COUNTY COUNCIL'S RESPONSE TO CONSULTATION ON THE FOLLOWING DEVELOPMENT PROPOSAL

Application No: 17/02190/F-2

Proposal: Proposed pilot training school comprising a 4 storey accommodation block, 2 storey teaching and training block, parking for cars, cycles and motorcycles, access road and landscaping

Location: Land West Of The Junction With The Boulevard, Oxford Airport, Langford Lane, Kidlington.

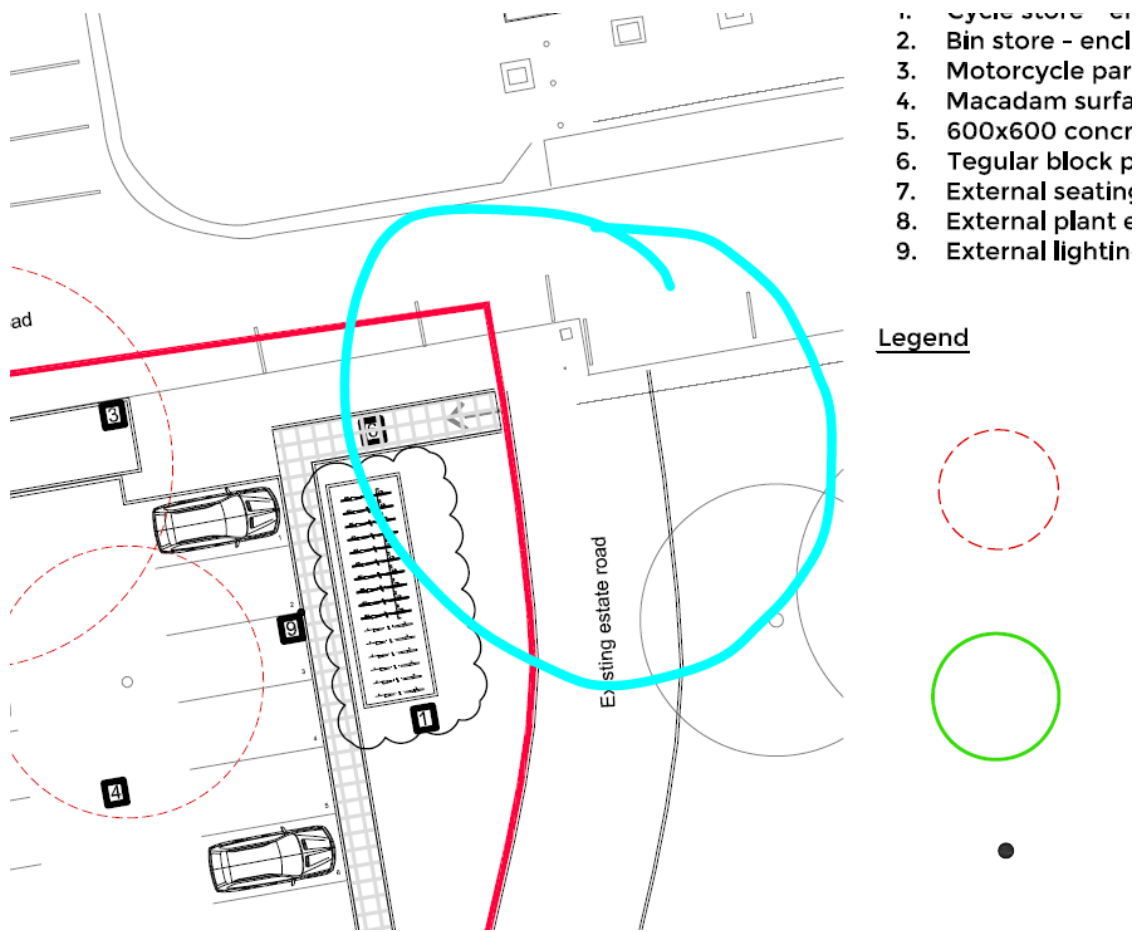
It is very difficult to understand from the Transport Statement (TS) how many traffic movements this proposed development will generate. An attempt has been made in Table 5.1 but these numbers are not sufficiently well justified – *“These rates are based on the experiences of the Head of Business Development at the London Oxford Airport”*.

The experience of the head of business is not sufficiently robust justification. Especially given that 16 and 20 two way trips in the morning and evening peaks respectively does not seem very realistic even if 78 of the total 120 students attending the training live on site in the accommodation.

There are also 50 members of staff associated with this development to be taken into account. A much clearer and robust explanation is needed of how and when students and staff will move to and from the facility. Are there really no surveys of existing activity for pilot training at the airport that can be used to base an estimate on for this new site?

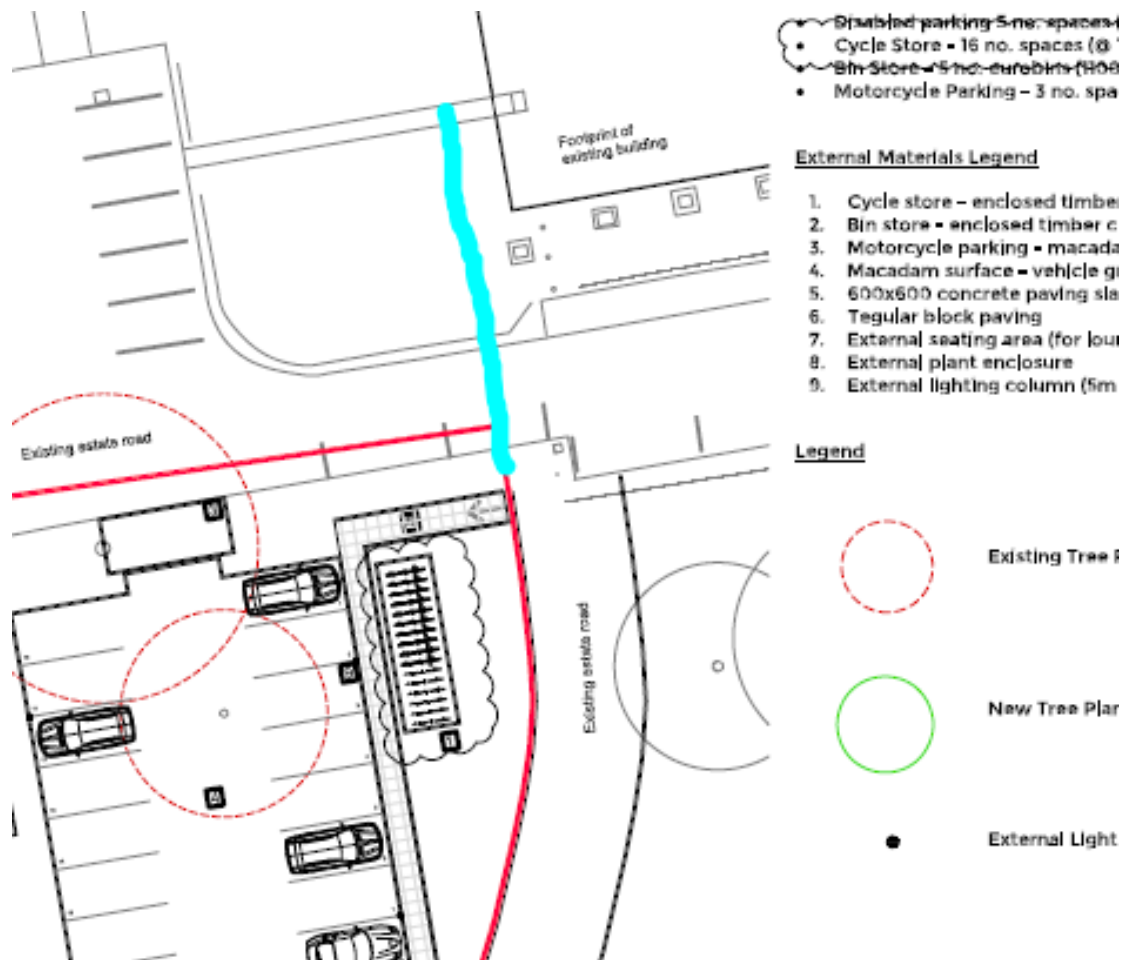
The layout of the existing estate road does not appear to accurately represent what is on site – particularly the bell mouth on the east side of the access:

The junction of this existing estate road also doesn't seem to be in the correct position on the plan – on the ground, the western edge of the road is approximately in line with the edge of the building opposite – on the plan it is not (compare the following two screen shots). This must be clarified.

It is not clear how this access is to be designed and built and there is no tracking showing how large vehicles will enter and leave the site. I would expect a full bellmouth to be needed here to accommodate the possible range of vehicle movements.

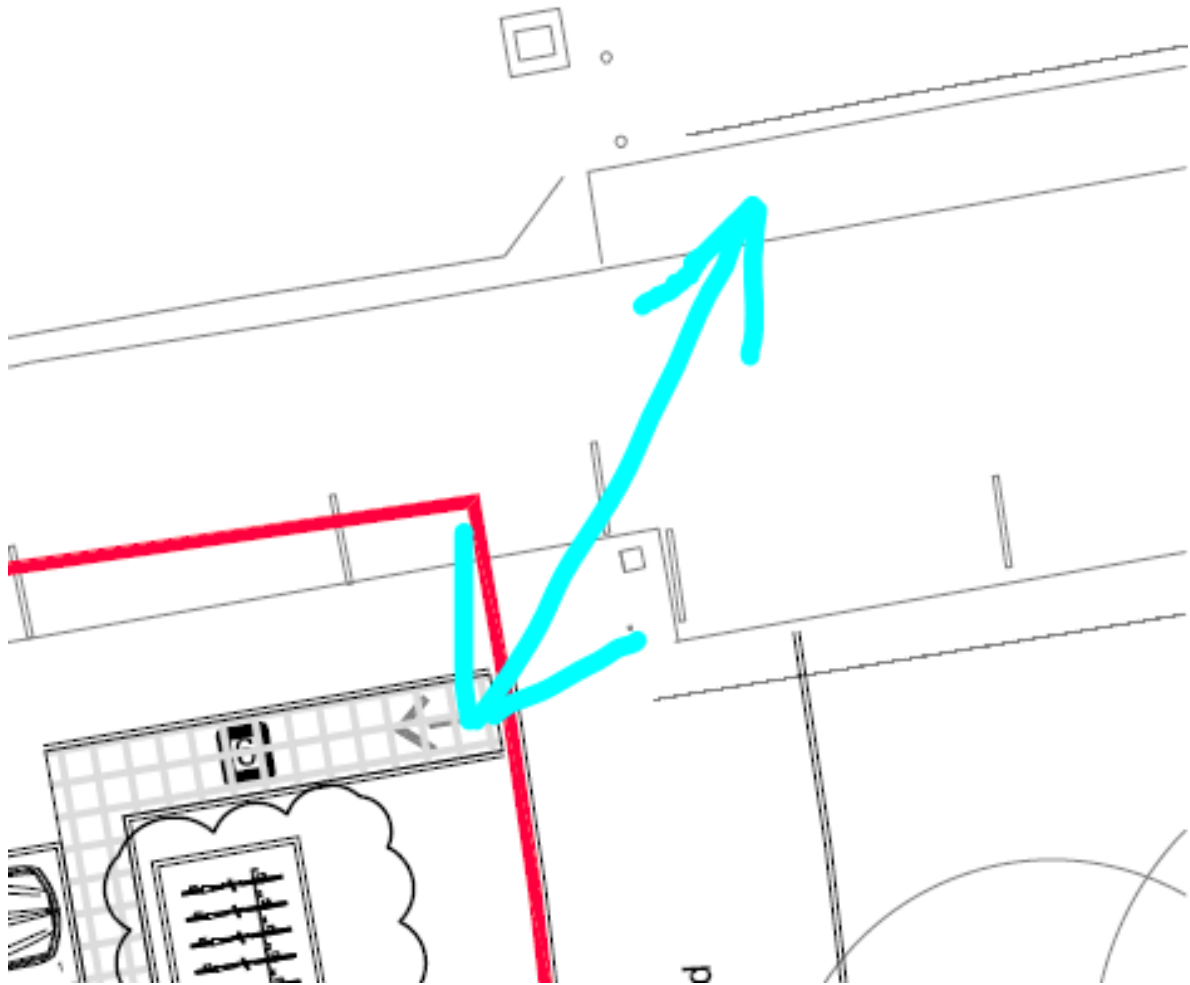
There is a vehicle access barrier on the existing estate road that was up when I visited the site but clarification is needed whether this barrier is to remain and if so how it is to be managed.

Some tracking manoeuvres have been shown on the proposed site plan for the entrance off the existing site road but they are very feint and it is not possible to work out the type and size of vehicle that has been tracked. Clarification is needed on tracking including for the exit (which has had no tracking submitted at all).

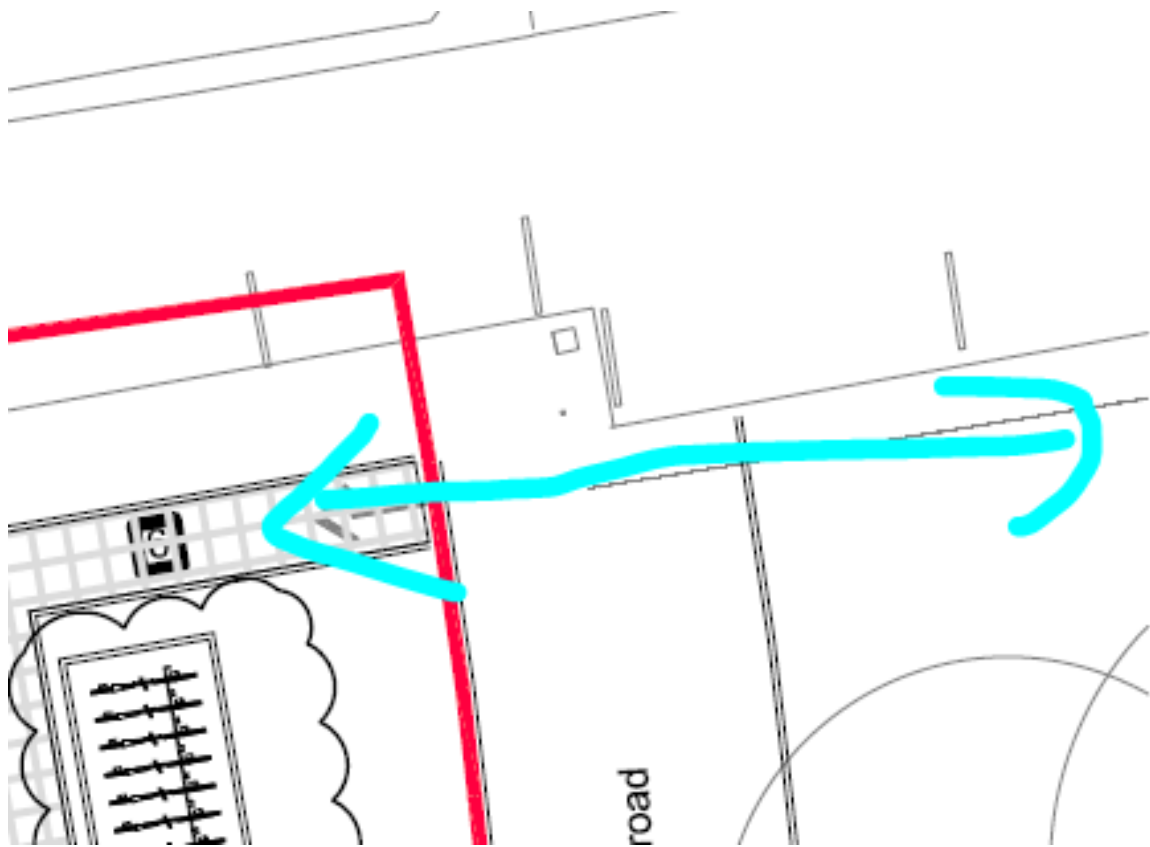
It is also not clear how pedestrians would get to and from the existing footway provision to the north side of the first stretch of estate road after the junction with The Boulevard:

The onward pedestrian route from that point to the nearest bus stops on Langford Lane (buses do not run throughout the day from the stops on The Boulevard contrary to what the TS suggests). A much better solution would be for a new footway to be provided on the south side of the access road, west of the Boulevard:

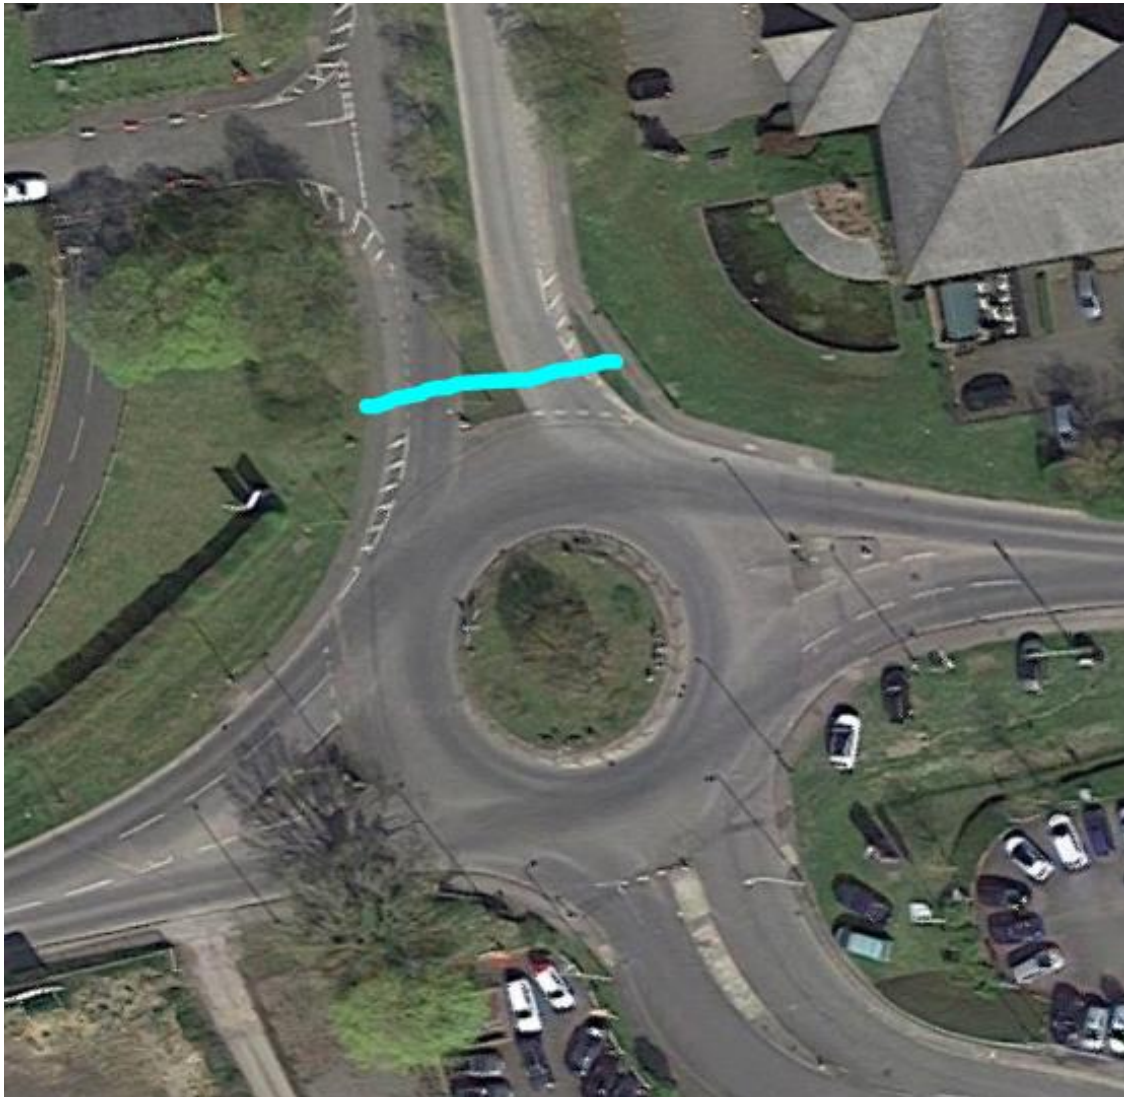
This would then provide a more convenient route to the existing footway on The Boulevard. However, there is currently a run of red and white plastic barriers along the first stretch of site access road which I understand to be preventing car parking. This prevents safe and suitable access to the footway on The Boulevard and as such is blocking the public highway:

It is clear that the barriers need to be removed and in any case surely are a temporary measure. But how is the parking going to be prevented in the future without them? Double yellow lines (even though it is not a public highway) would be a good start.

Once onto the footway on the west side of The Boulevard, a route exists to and across Langford Lane (but for a distance this is in the opposite direction to the eastbound bus stop on Langford Lane) and then eastwards along Langford Lane crossing the Motor Park side road at a refuge island. Pedestrians can then continue eastwards to the point where a refuge island crossing will be provided to get to the eastbound bus stop. A more attractive and direct route would be across The Boulevard by the roundabout and then crossing Langford Lane to the east of the roundabout – it would be approximately 50m shorter to the position of the new Langford Lane refuge crossing. And it would not involve a walk in the wrong direction. The applicant should therefore provide a new refuge crossing of The Boulevard north of the roundabout by means of a S278 agreement:

- A refuge island crossing of The Boulevard immediately north of the Langford Lane roundabout needs to be provided
